# Access Compliance Report
Public Rights-of-Way
(Curb Ramps)

Intersection ID: 42482	Main Street: BLAKENEY_GREENS_BV	Cross Street: REA_RD		Location:	NE
ADA ID: 23EB5A80FEBB	Ramp Type: PerpDiag	Initial Pass/Fail: Fail	Overall Compliance: No	Severity Score:	25

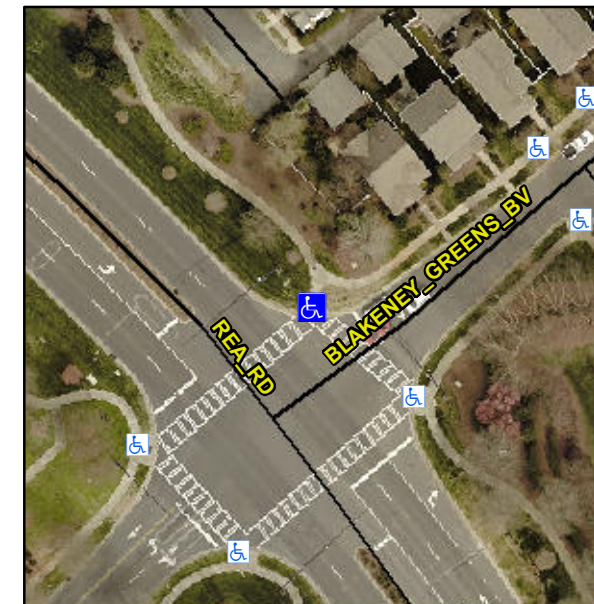
Not Found, R304.5.3

Compliance	Description	Data	Compliance	Description	Data
N/A	Ramp Length (in)	184.0	Yes	Ramp Slope (%)	10.3
Yes	Ramp Width (in)	58.5	No	Ramp XSlope (%)	5.5
N/A	Flare Type LT	N/A	N/A	Flare Type RT	N/A
N/A	Flare Slope LT (%)	N/A	N/A	Flare Slope RT (%)	N/A
N/A	Flare Traversable LT?	N/A	N/A	Flare Traversable RT?	N/A
N/A	Landing Length (in)	N/A	N/A	DWS Provided?	N/A
N/A	Landing Width (in)	N/A	N/A	DWS Contrast?	N/A
N/A	Landing Slope (%)	N/A	N/A	DWS Length (in)	N/A
N/A	Landing X Slope (%)	N/A	N/A	DWS Full Width?	N/A
N/A	Landing Curb? (Y/N)	N/A	N/A	DWS Offset (in)	N/A
N/A	Shared Landing?	N/A			
N/A	Gutter Ponding?	N/A	N/A	Gutter Slope (%)	N/A
N/A	Gutter Lip Ht (in)	N/A	N/A	Gutter X Slope (%)	N/A
N/A	Painted X Walk1?	No	N/A	Painted X Walk2?	No
	X Walk 1 Direction	To SE		X Walk 2 Direction	To SE
N/A	X Walk 1 Width (in)	N/A	N/A	X Walk 2 Width (in)	N/A
	X Walk 1 Slope (%)	0.0		X Walk 2 Slope (%)	3.0
	X Walk 1 X Slope (%)	3.3		X Walk 2 X Slope (%)	0.4

Remove & Replace Curb Ramp With Two New Directional Ramps or Equivalent.
